## DART SERVICE INSTRUCTION

TO AMEND INSTALLATION INSTRUCTIONS D350-589 REV. E AND EARLIER AND INSTRUCTIONS FOR CONTINUED AIRWORTHINESS ICA-D350-589 REV. 1 AND EARLIER REF. TCCA STC: SH92-41

REF. TCCA STC: SH92-41 REF. FAA STC: SH1012NE REF. AUSTRIAN STC: ACG.21NE2.093

The purpose of this DSI is to provide instruction for the relocation of the door switch when the D35X-589-041/-042/-043 Side Door Assemblies are installed per D350-589 Rev. E and earlier and to clarify that the OEM center latch is not required with the D35X-589-041/-042/-043 kits.

## FIGURE 1: DSI 9446-011 SWITCH RELOCATION KIT INSTALLATION

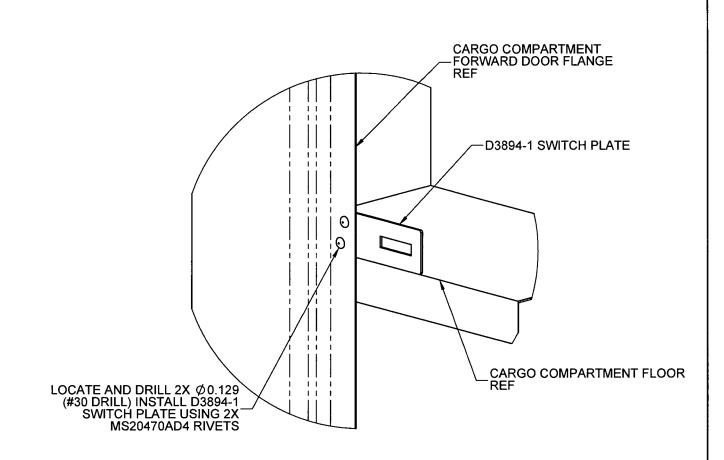
The DSI 9446-011 Switch Relocation Kit may be installed by relocating the door switch using the following procedure:

- 1) Remove the existing door switch (p/n 2-5445), switch support (p/n 350A67-6323-32) and spring (p/n 350A67-6323-31) from the forward lower edge of the cargo compartment.
- 2) Position the D3894-1 switch plate near the bottom of the flange adjacent to the cargo compartment floor so that the switch will contact the door directly. See Figure 1.
- 3) Locate and drill 2x Ø0.129 (#30 drill) holes from D3894-1 switch plate to the cargo compartment flange. Deburr holes and attach D3894-1 switch plate to the flange of the cargo compartment using 2x MS20470AD4 rivets.
- 4) Position the door switch in the hole provided in the D3894-1 switch plate.
- 5) Reconnect wiring to switch (if removed) and verify that switch operates correctly. It may be necessary to hand-form/trim the D3894-1 switch plate slightly to ensure that the switch contacts the door properly.

If the cargo compartment has a second switch installed in the center latch, it is not necessary to relocate this switch. The wiring should be removed and stowed so that this switch no longer turns on the cockpit indication.
